ADDENDUM NO. 2

FEBRUARY 28, 2024

Staunton City Public Schools, VA
Shelburne Middle School Additions and Renovations
CRA Project No. 3636

ED1.1

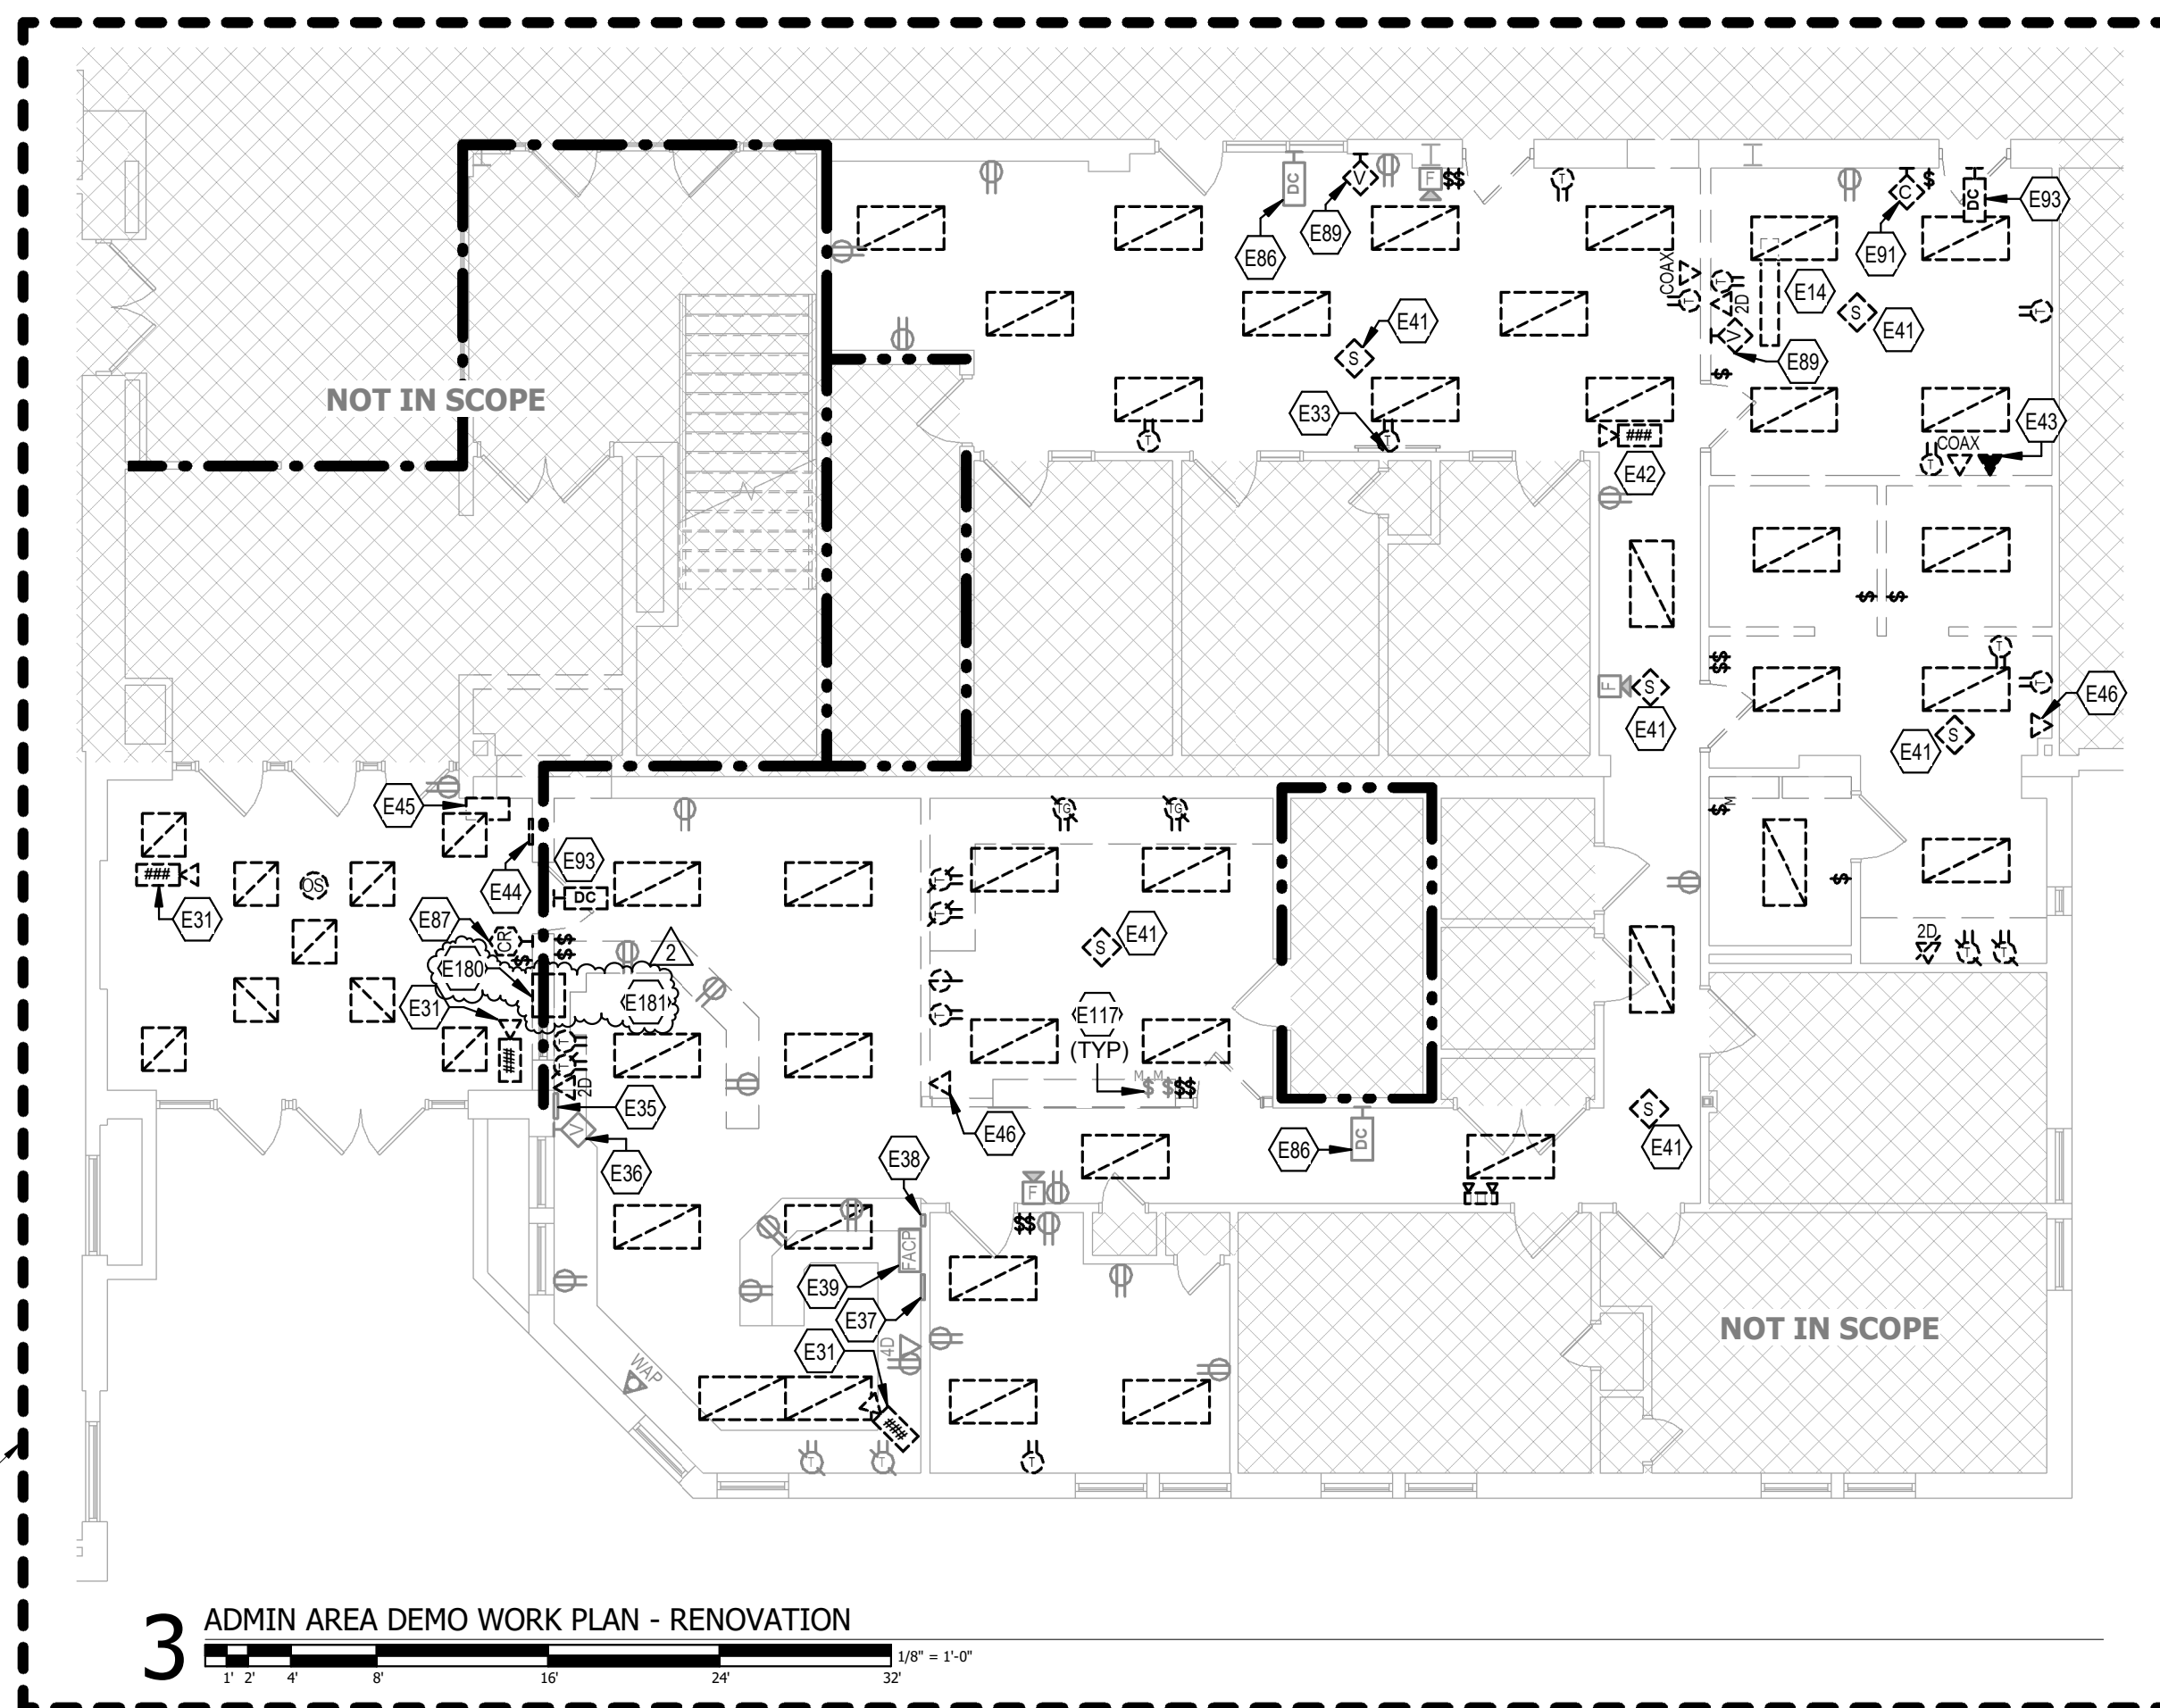
1. **DELETE** this sheet in its entirety and **REPLACE** with the attached sheet.
 - a. **ADD** keynotes E180 and E181 to clarify existing/demo conditions in admin area.

1 ELECTRICAL DEMO PLAN - SITE

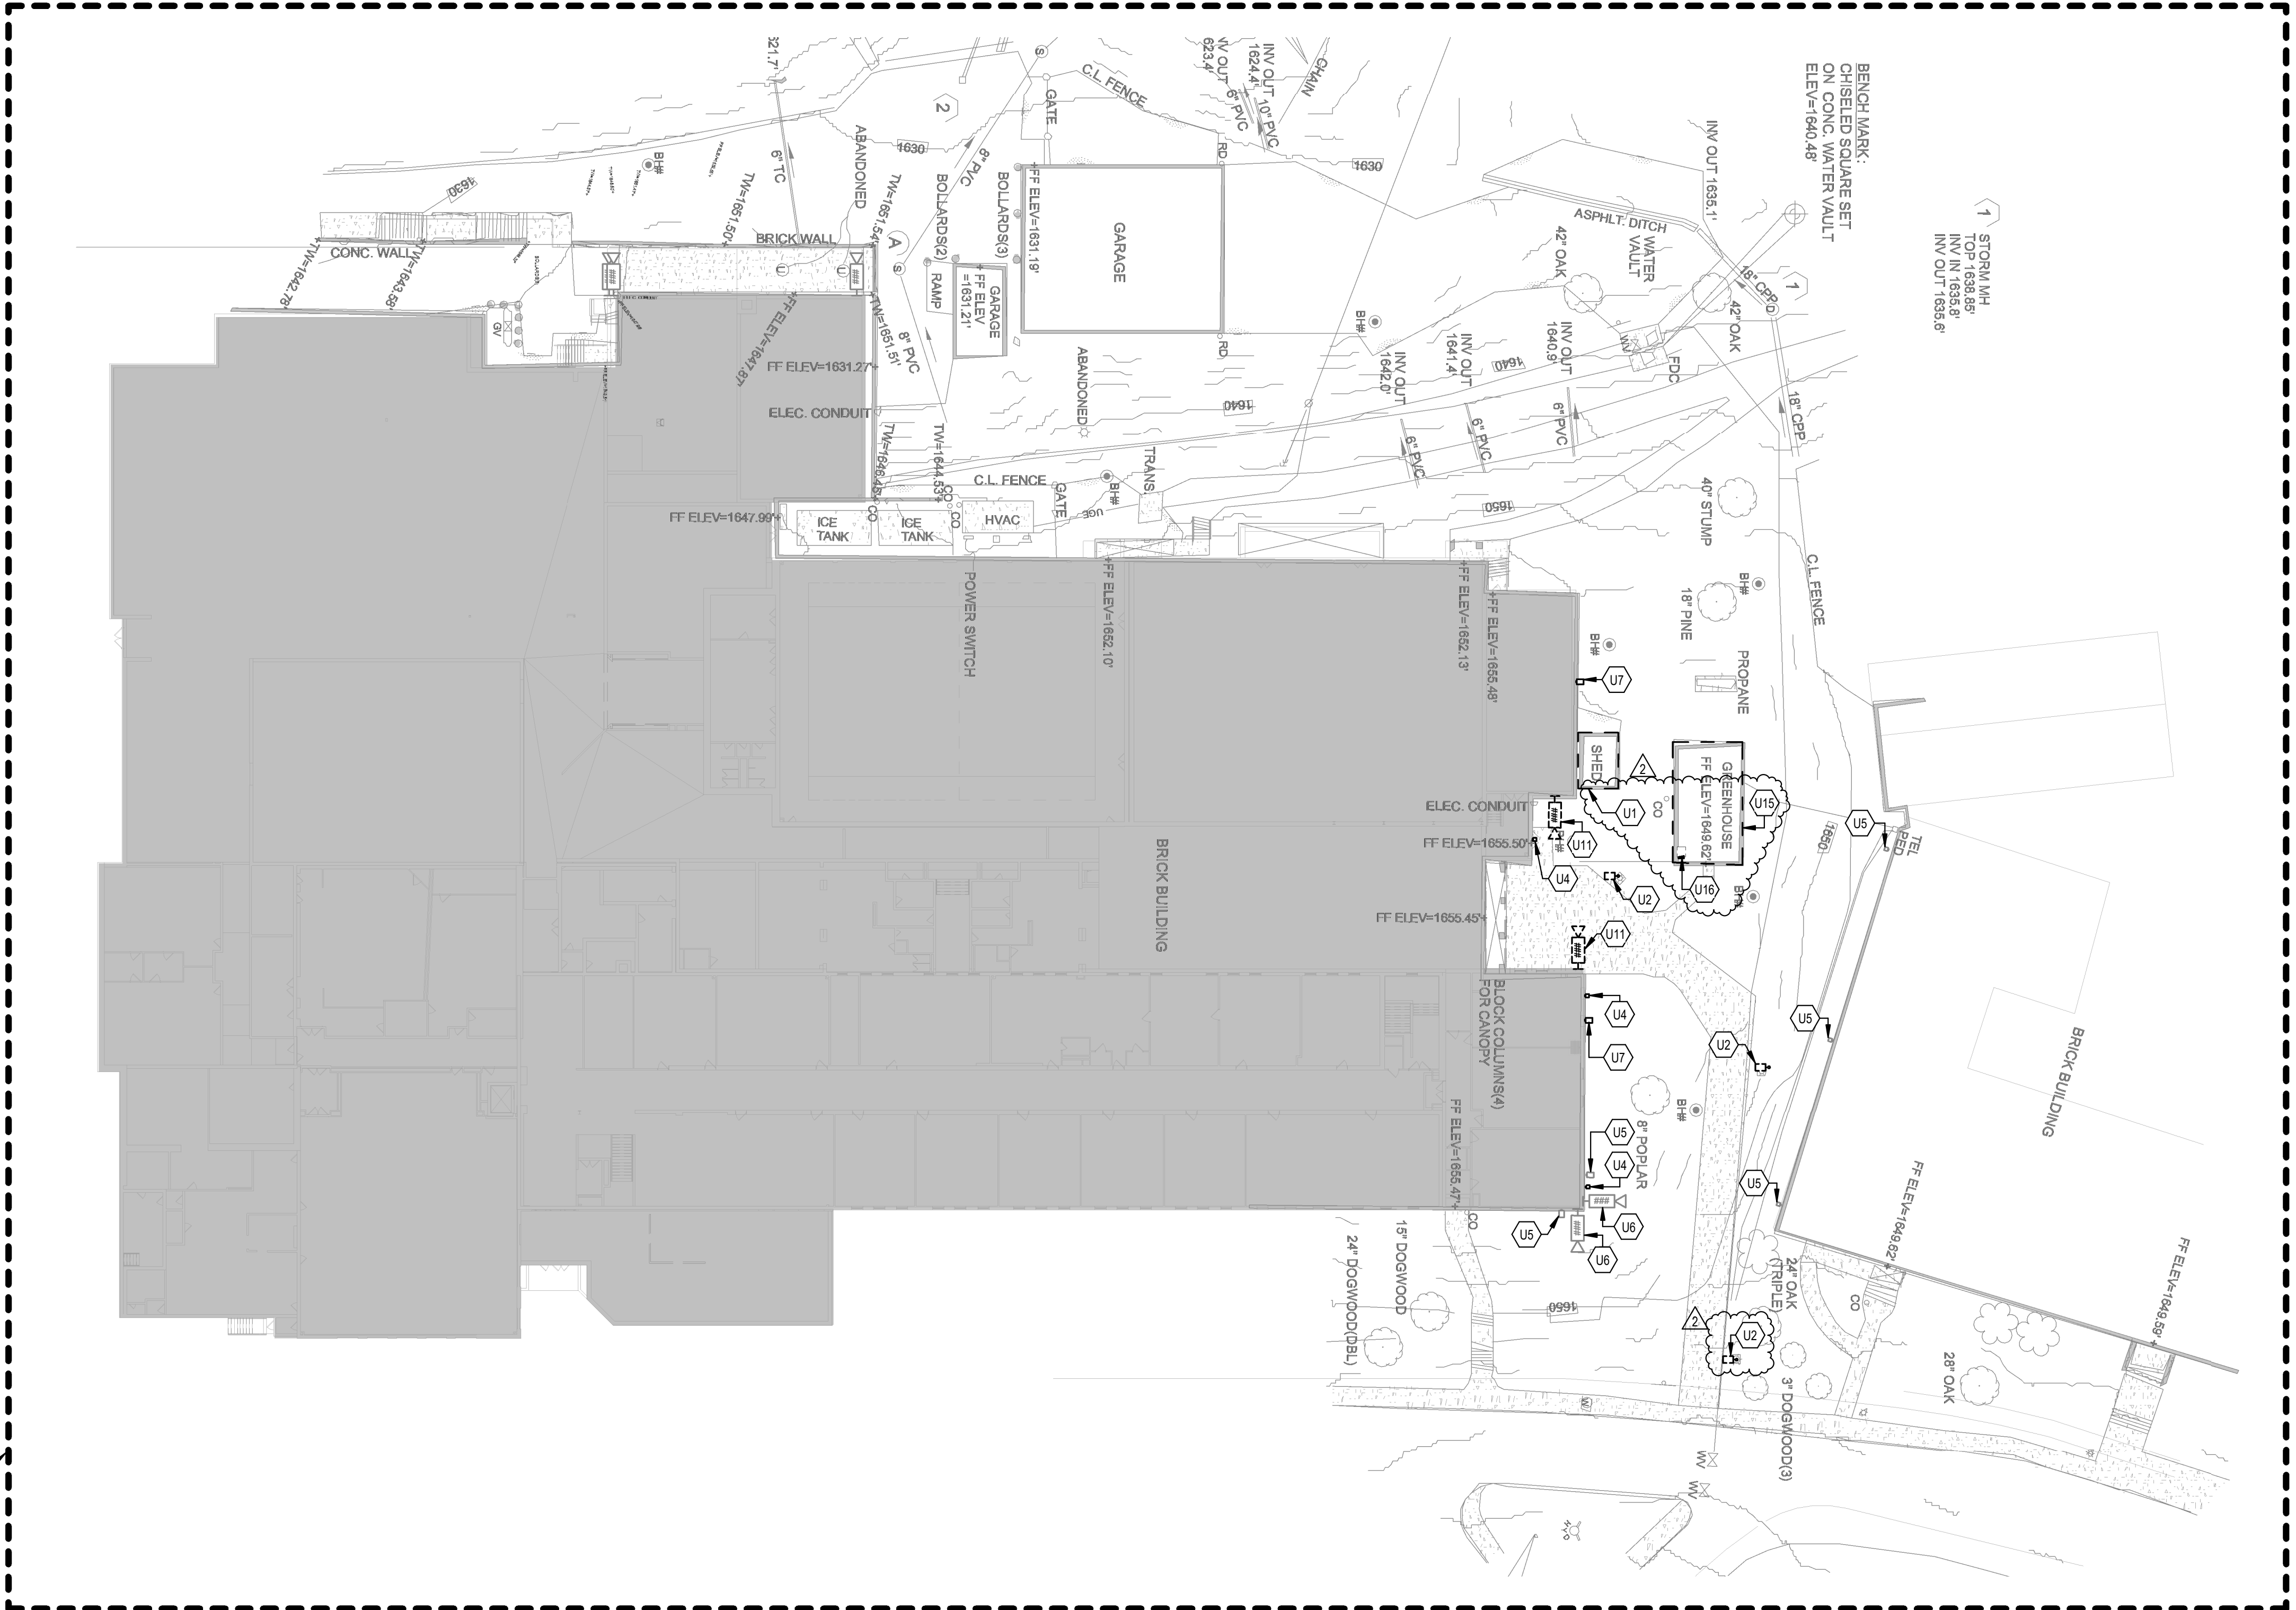
1. **DELETE** this sheet in its entirety and **REPLACE** with the attached sheet.
 - a. **ADD** note to clarify that all work on this sheet is to be included as a part of Alternate #1.
 - b. **REVISE** keynote U1 to clarify extent of demolition for site structures.
 - c. **ADD** keynotes U15 and U16 to clarify extent of work related to relocation of greenhouse.
 - d. **ADD** demolition of (1) pole-mounted site light.
